**COST REQUEST**

DATE: May 7, 2007  
COST REQUEST NO. 1  
TO: McCrary Construction  
FROM: John Dybczak  
PROJECT: Napa Valley College Wine Storage Building  
PROJECT NO.: 05067.00

DATE: May 23, 2007  
COST REQUEST NO. 2  
TO: McCrary Construction  
FROM: John Dybczak  
PROJECT: Napa Valley College Wine Storage Building  
PROJECT NO.: 05067.00

Sheet R-1  
1 of 1

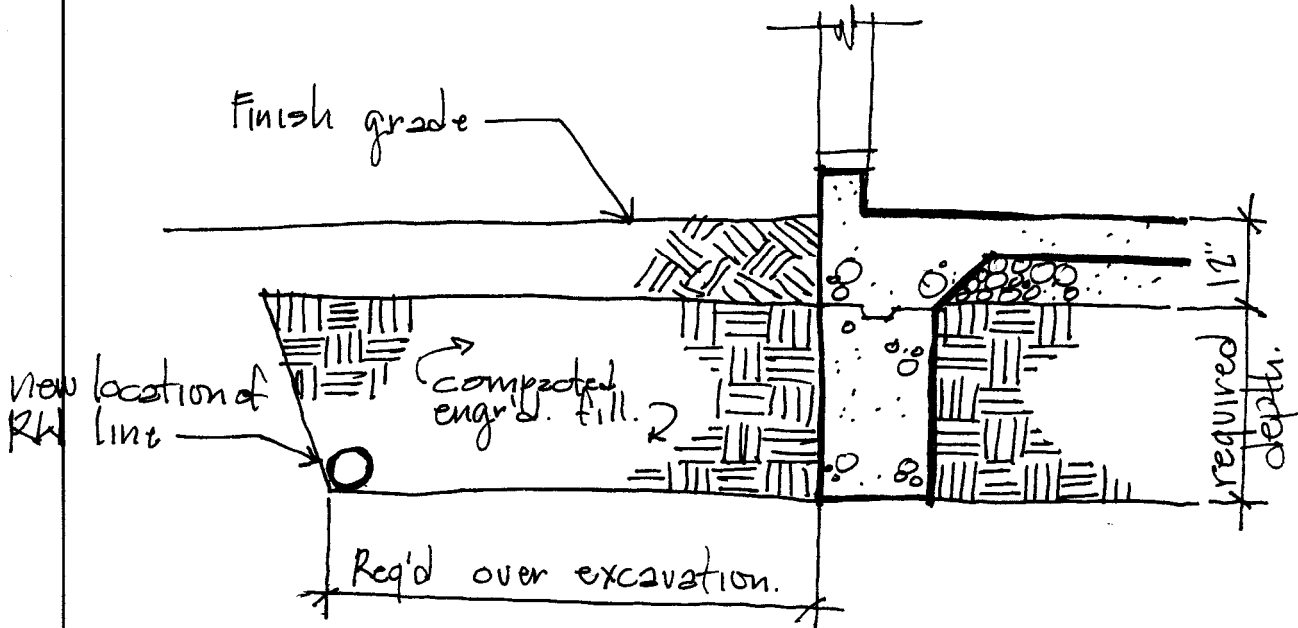
Please provide a cost (per General Conditions, Item 28b) to relocate the existing 4" reclaimed water line at the north side of the building and the 2" reclaimed water line at the west side of the building to the outside of the over excavated area per the attached sketch R-1.

# AE1.15

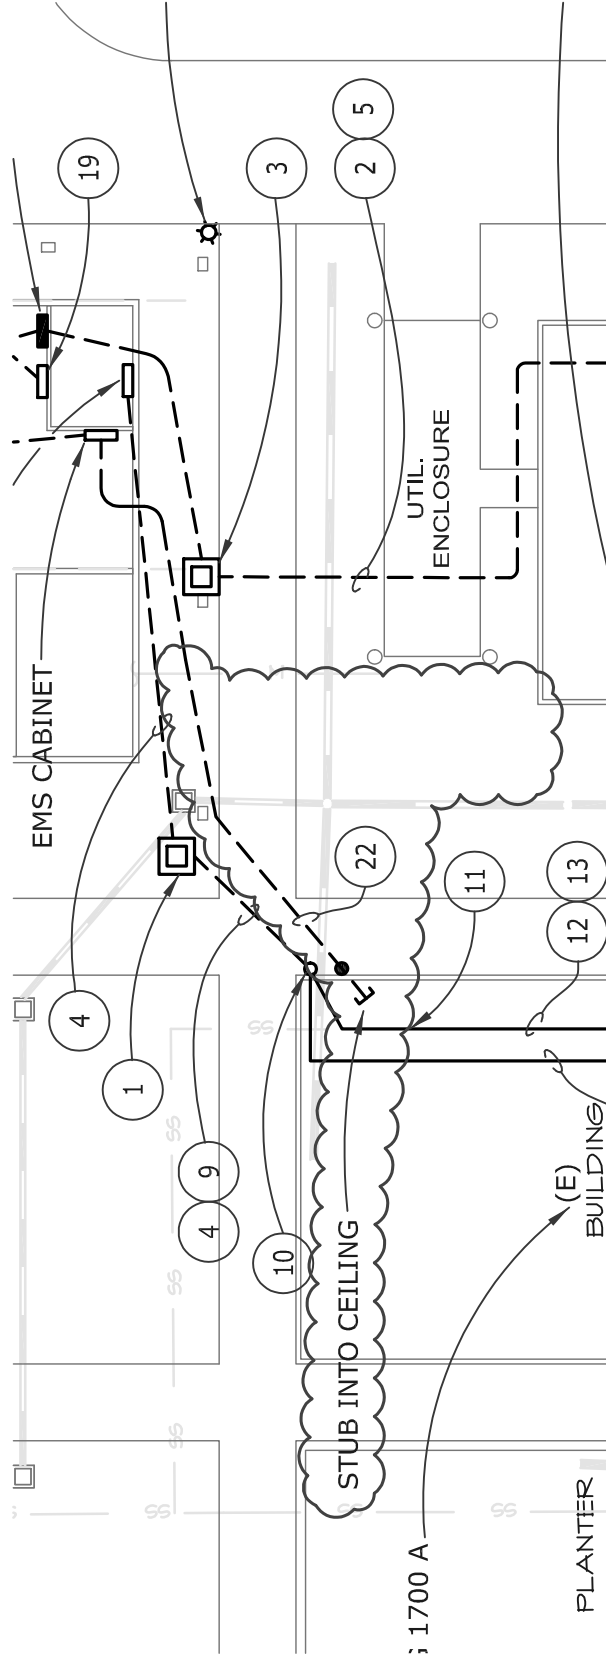
Please provide a cost (per General Conditions, Item 28b) for the Owner's review to provide and install two 2" conduits from existing building 1700A to storage building for new EMS and fire alarm wiring per the attached drawing AE1.15.

22 PROVIDE AND INSTALL TWO 2" CONDUITS FROM EXISTING BUILDING 1700A TO NEW STORAGE BUILDING FOR NEW EMS WIRING AND FUTURE FIRE ALARM WIRING.
